ITEM 26

FINAL PLAT REVIEW FOR STONE RIDGE LLE SUBDIVISION, CONTAINING 5 LOTS ON 69.98 ACRES LOCATED OFF HARPETH SCHOOL ROAD IN THE 2ND VOTING DISTRICT (1-2025-411).

FINAL PLAT REVIEW FOR STEPHENS VALLEY SUBDIVISION, SECTION 12, CONTAINING ZERO (0) LOTS ON 0.77 ACRES LOCATED OFF STEPHENS VALLEY BOULEVARD IN THE 8TH VOTING DISTRICT (1-2025-429).

CONCEPT PLAN REVIEW (REVISED) FOR KINGS CHAPEL SUBDIVISION, CONTAINING 449 LOTS ON 615.28 ACRES LOCATED OFF MULLENS ROAD IN THE 5TH VOTING DISTRICT (1-2025-209).

ATTACHMENT 26-1B

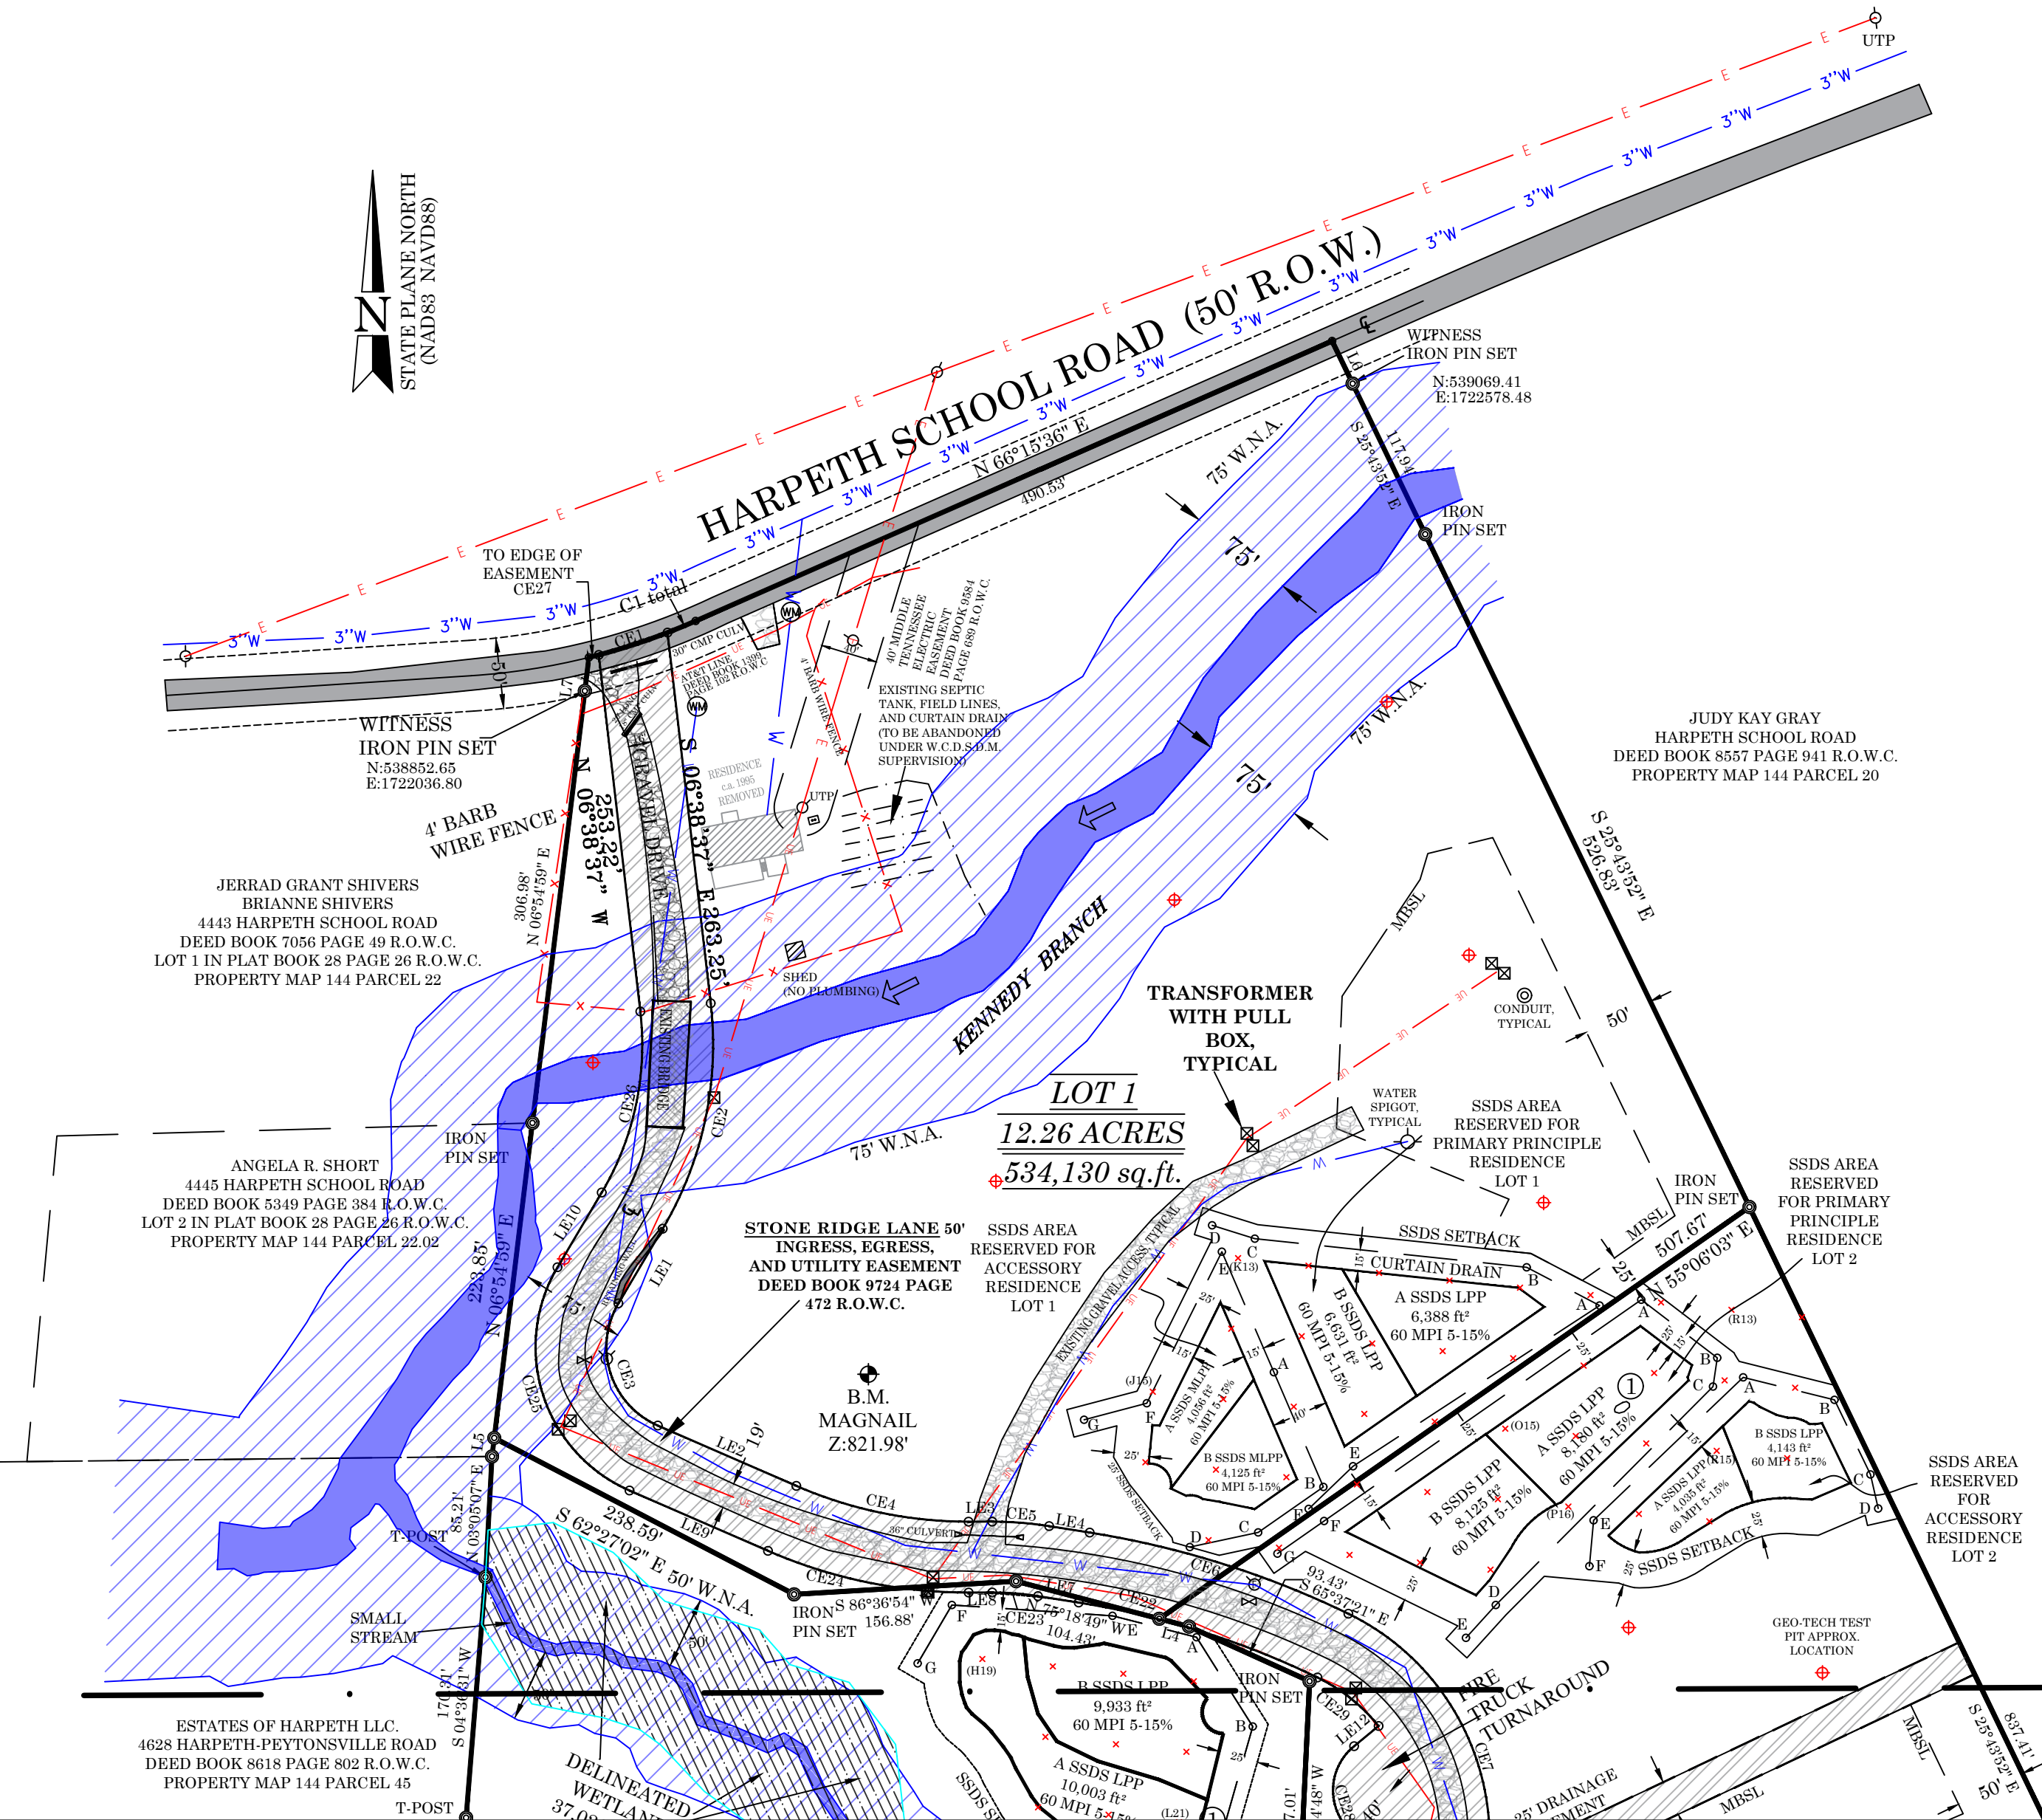
A Preliminary Plat for this development was approved at the January 2024 Planning Commission meeting. The applicant is now requesting Final Plat approval of the development, which contains five (5) lots on approximately seventy (70) acres, accessed by a fifty-foot (50') ingress/egress/utilities easement.

The Final Plat conforms with the approved Preliminary Plat, and Staff recommends approval with the following conditions:

1. The applicant shall adopt and record a covenant that declares that the access easement is not a public road, and imposes the requirement of maintenance by all property served by the access easement. The covenant shall be recorded concurrently with the recording of the plat; and
2. Demonstration of compliance with Section 3.05 of the Subdivision Regulations, Fire Apparatus Access, prior to Building Permit Issuance.

ATTACHMENT 27-1

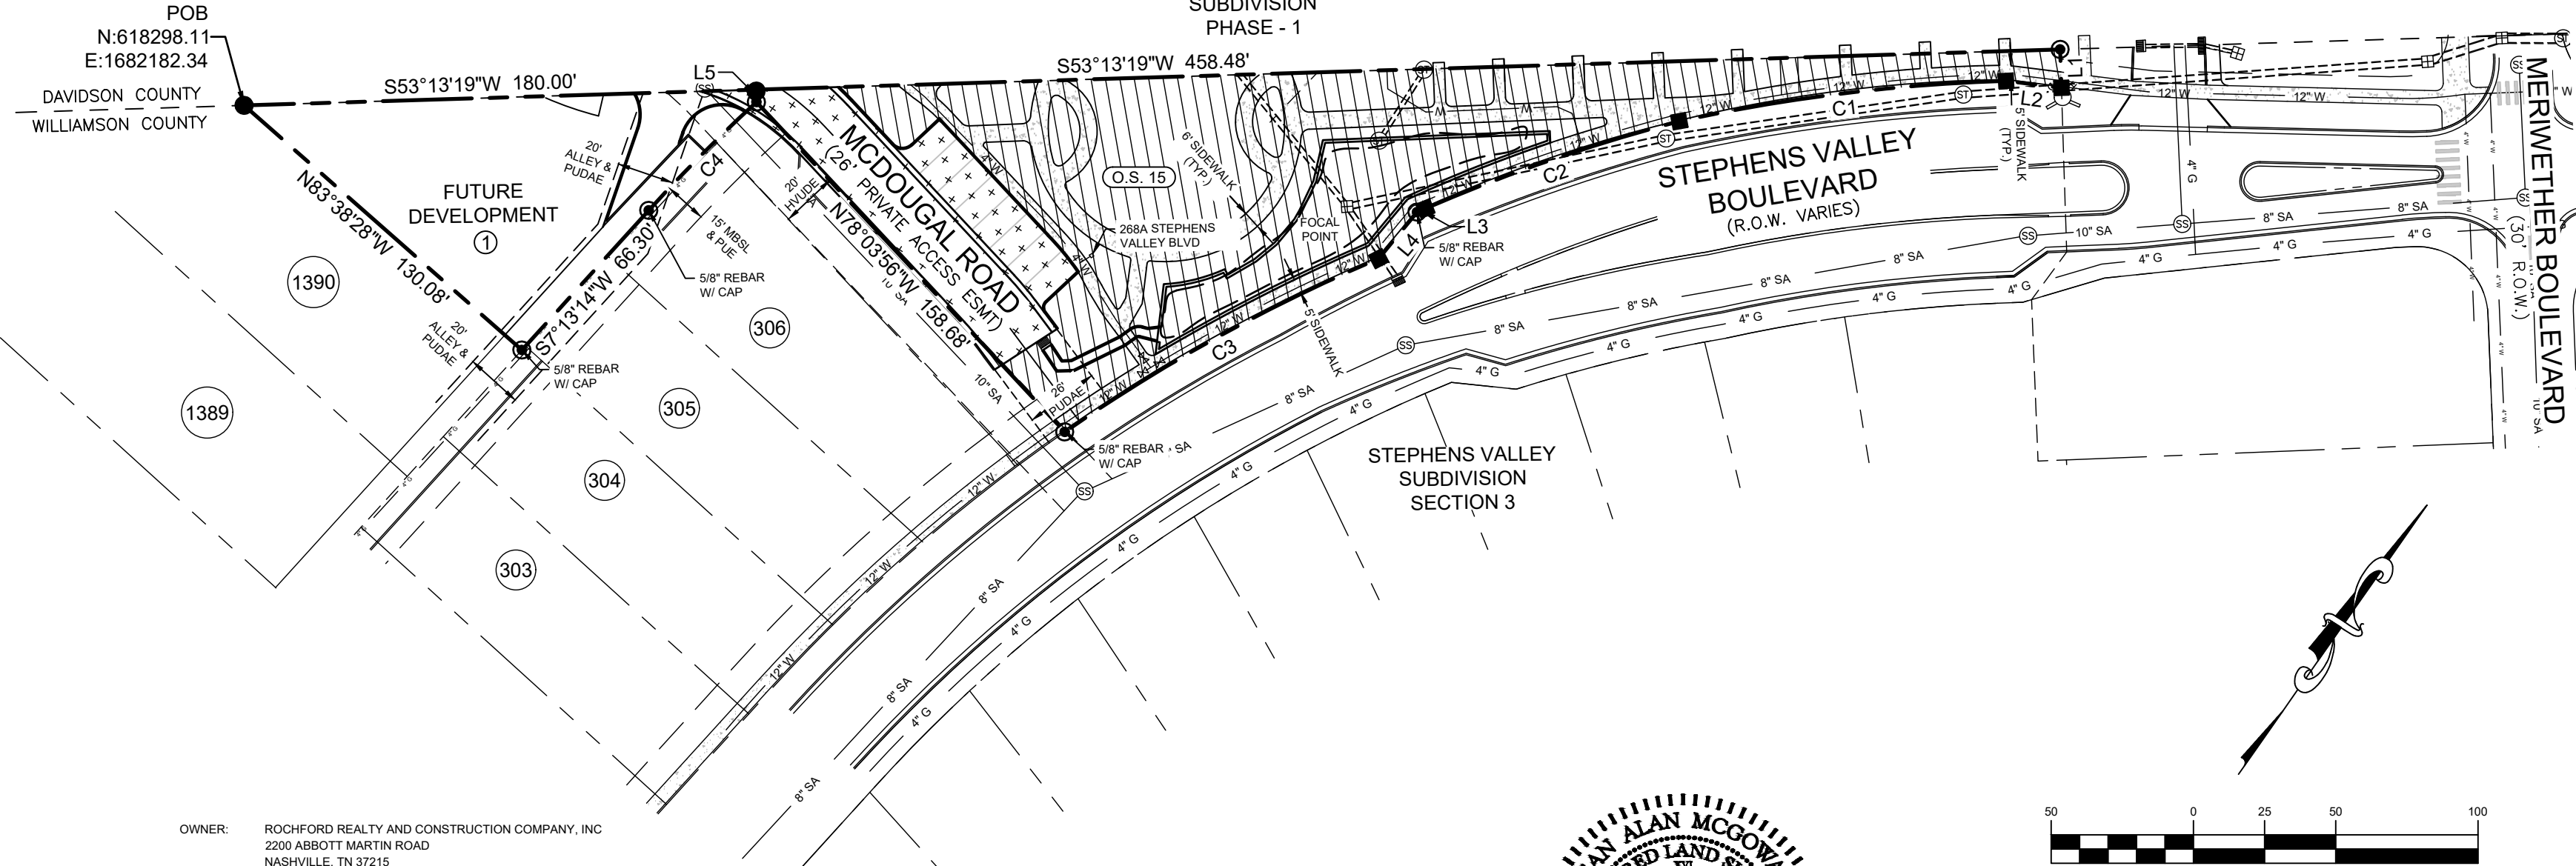
A Preliminary Plat for this Phase of the development was approved by this body at the July 2025 meeting, and the applicant now is requesting Final Plat approval for Section 12, which does not contain any buildable lots. The Final Plat will designate 0.53 acres as Open Space. The plat is consistent in layout with the approved Preliminary Plat.

The Final Plat is in order and Staff recommends approval with the condition that the Applicant submit the approved Final Plat in .dwg format on recordable media based on the Tennessee State Plane Coordinate System prior to signature and recording of the plat.

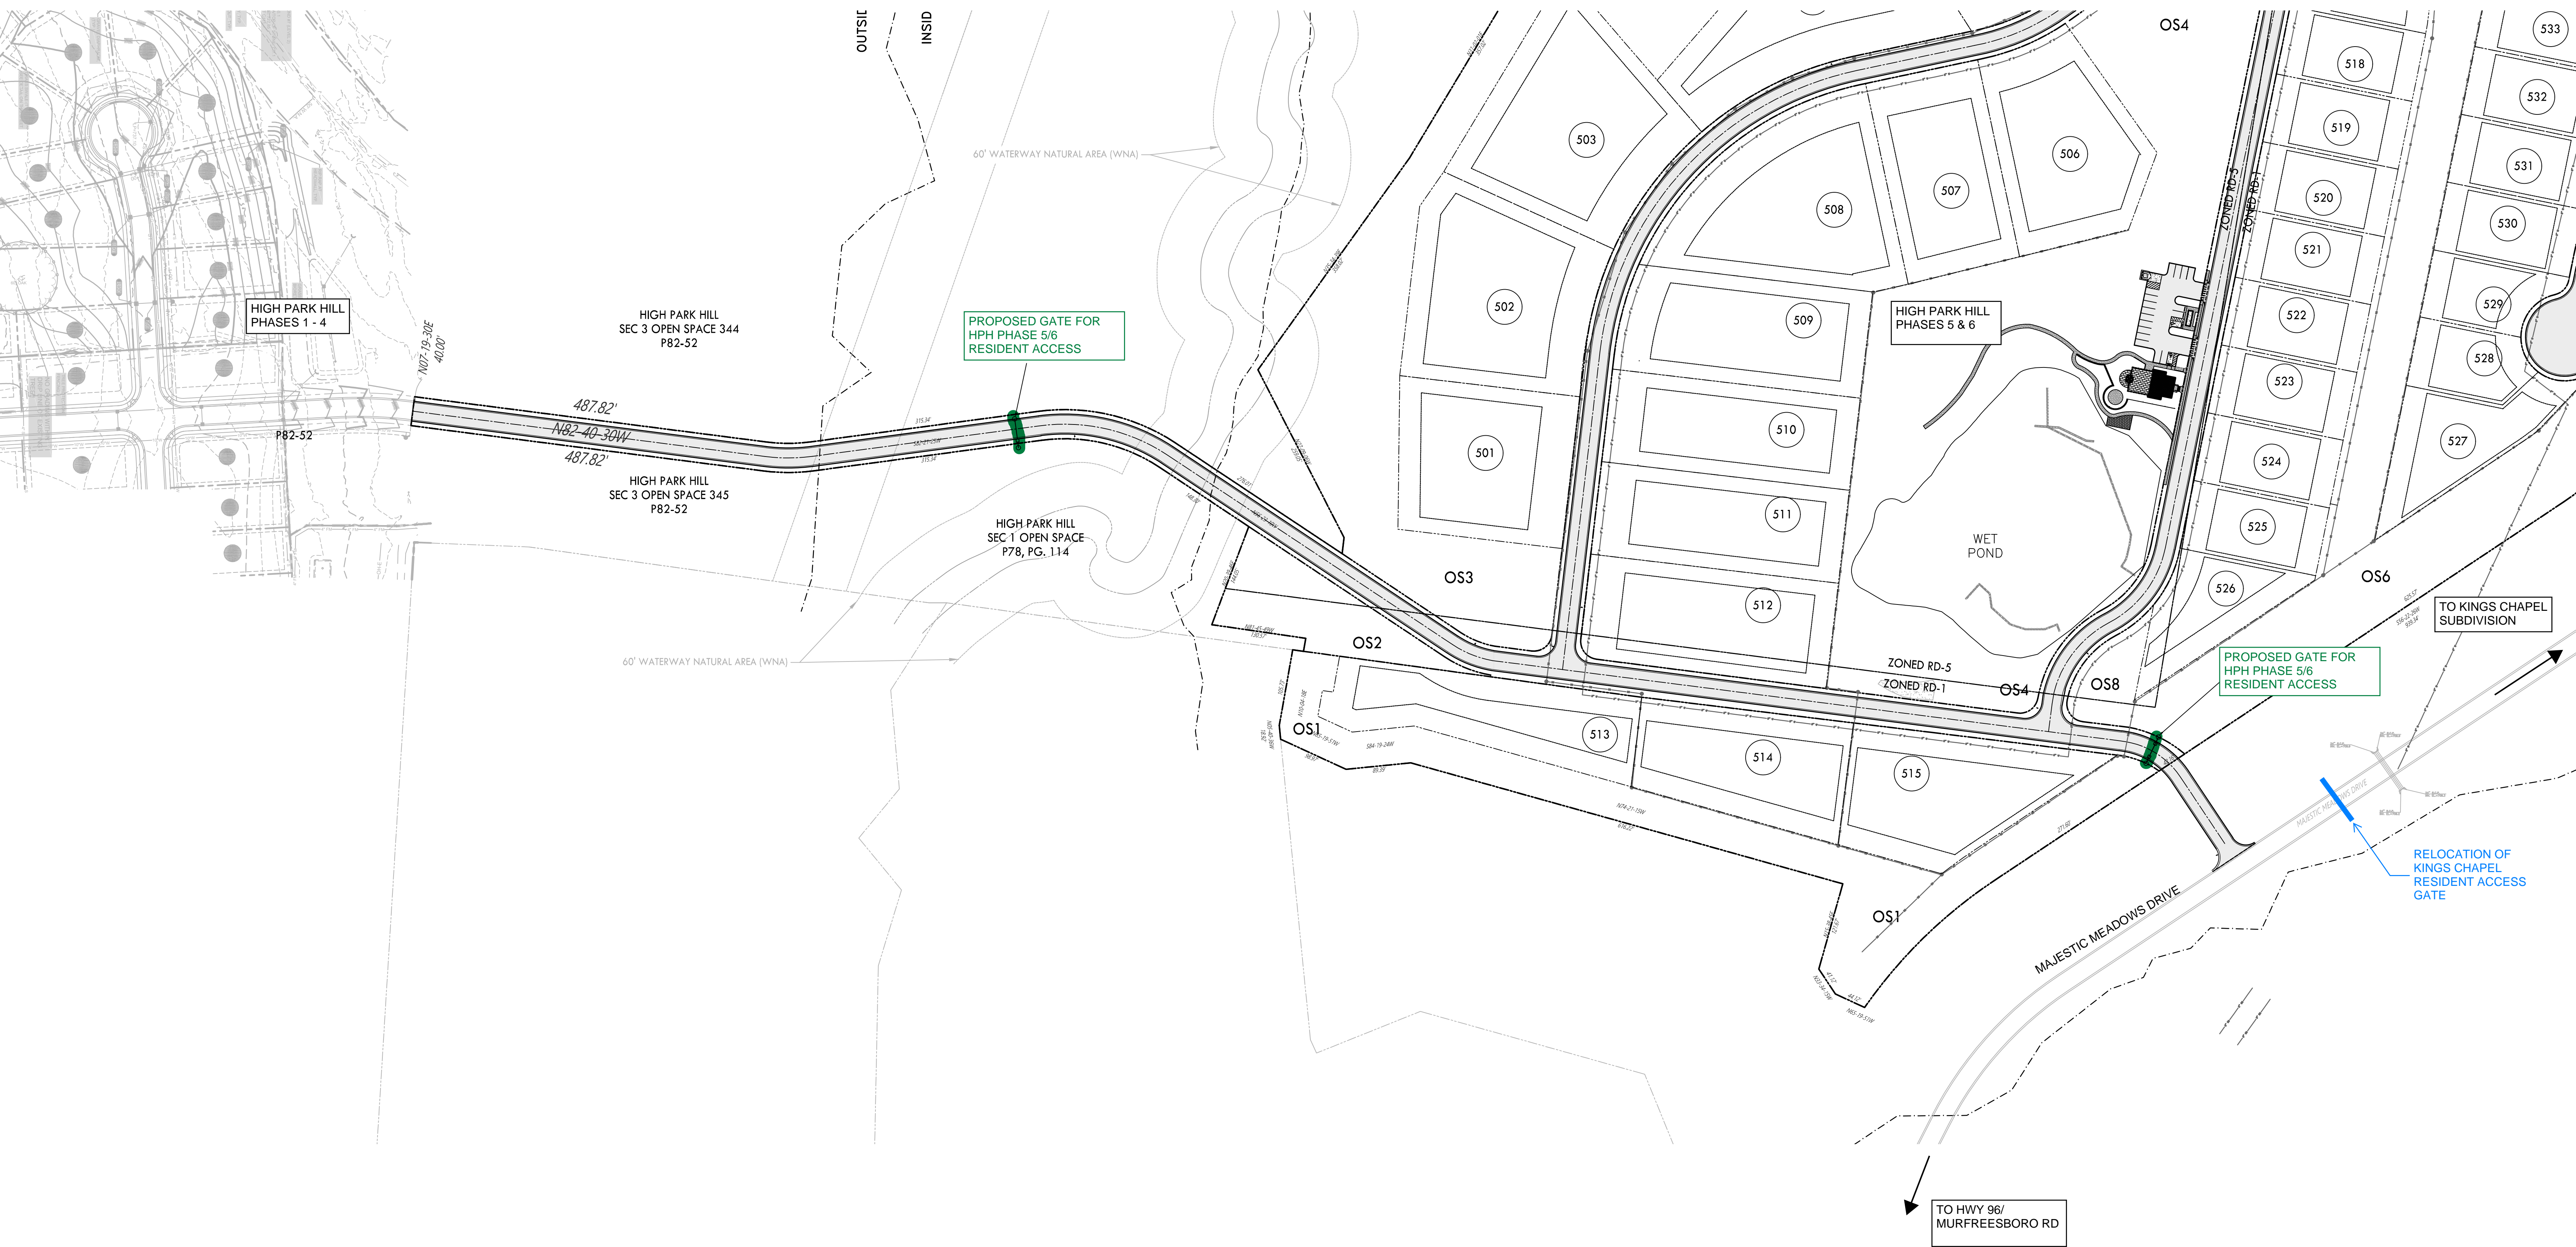
A Revised Concept Plan for this development was approved at the September, 2023 meeting. At that time, Staff recommended, and it was added as a condition of approval, that there be a single gated connection between the developments, which would be located in the High Park Hill development and restricted to emergency vehicles and utility service providers. This restricted connection would serve to delineate the developments as two separate and distinct developments (See Attachment 28-3). This emergency entry gate was located on Floryn Drive, north of the existing King's Chapel entry gate.

In June 2024, the applicant requested and was granted approval of another Revised Concept Plan in order to relocate the existing King's Chapel entry gate, which is currently located 1,300 feet north of the intersection of Majestic Meadows Drive and Murfreesboro Road. This entry gate is to be relocated north of the intersection of Majestic Meadows Drive and Floryn Drive. Floryn Drive is the roadway connecting High Park Hill to King's Chapel. At this same meeting, the condition that there be a single gated connection between the developments and limited to emergency vehicles and utility service providers was carried over to the approved Concept Plan (See Attachment 28-4).

At this time, the applicant is requesting approval of another revised Concept Plan in order to remove the condition that the single gated connection between King's Chapel and High Park Hill be restricted to emergency vehicles and utility service providers. According to the applicant's Letter of Intent (See Attachment 28-5), the request is being made in order to "improve connectivity and safety for residents of the High Park Hill subdivision." The

applicant has noted that when the King's Chapel entry gate has been relocated, the residents from High Park Hill will not be able to enter King's Chapel.

Staff is of the opinion that the relocation of the existing King's Chapel entry gate to the new location north of Floryn Drive, which would be for the exclusive use of the residents of King's Chapel and prohibit entry into the development by the residents of High Park Hill, coupled with the placement of an entry gate for the exclusive use of the residents of High Park Hill that prohibits entry into the development by the residents of King's Chapel, would serve to delineate that these are two separate and distinct developments.

Therefore, Staff recommends approval of the Revised Concept Plan, with the removal of the condition stipulating that the one gated connection between King's Chapel and High Park Hill be restricted to emergency vehicles and utility service providers, and the added condition that the HOA documents be revised to provide for the maintenance of Majestic Meadows Drive by High Park Hill. The revised HOA documents shall be submitted with the next Final Plat of King's Chapel and High Park Hill developments, and recorded concurrently with the recording of the Final Plat.
